RESPONSE to the Recommendations of the Experimental Readiness Review for the CPP and NPP Experiments

April 28, 2021

Hall D E12-13-008/ E12-13-008A
Experiment Readiness Review
Jefferson Lab February 10, 2021 – remote

Report **Experiment Readiness Review for the Hall D experiments** **E12-13-008/E12-13-008A**

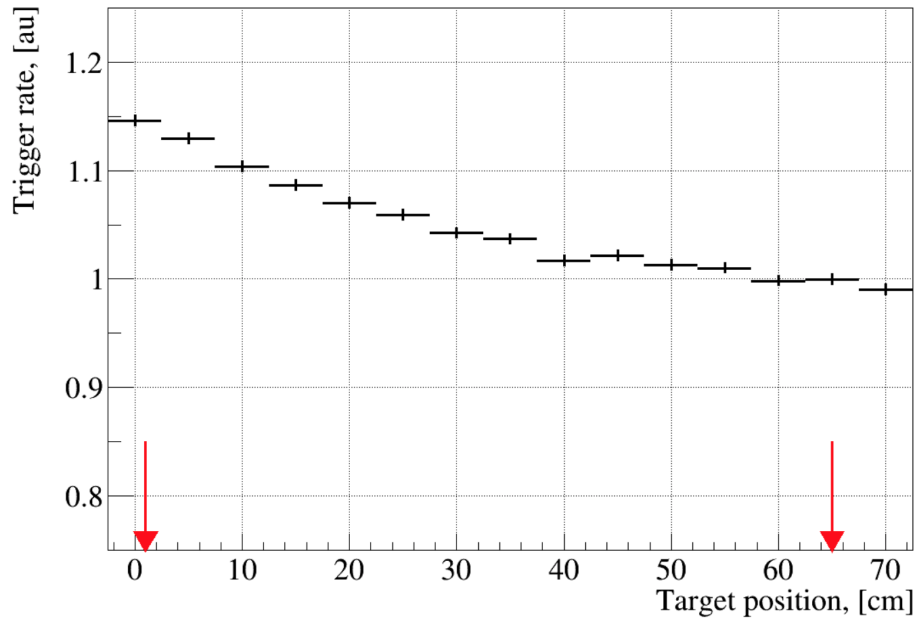
Provide the real measured rates and the details of how the 30 kHz rate was estimated. The provided estimates (for CPP and NPP) were based on the measured rates with the target at the nominal position. How much rate increase is expected from having the target ~60 cm upstream, including the rate from additional air downstream of the target.

- The analysis of the beam tests and trigger rates are provided in GlueX-doc-4796 (<https://halldweb.jlab.org/doc-private/DocDB/ShowDocument?docid=4796>).
- The effect of having the target 64 cm upstream of the nominal GlueX target increases the rates by about 15%. The rates as a function of target position are shown in the following plot computed with our hdgeant3 simulation of the experiment. The arrows indicate the nominal GlueX target center (65 cm) and the proposed CPP target position (1 cm).
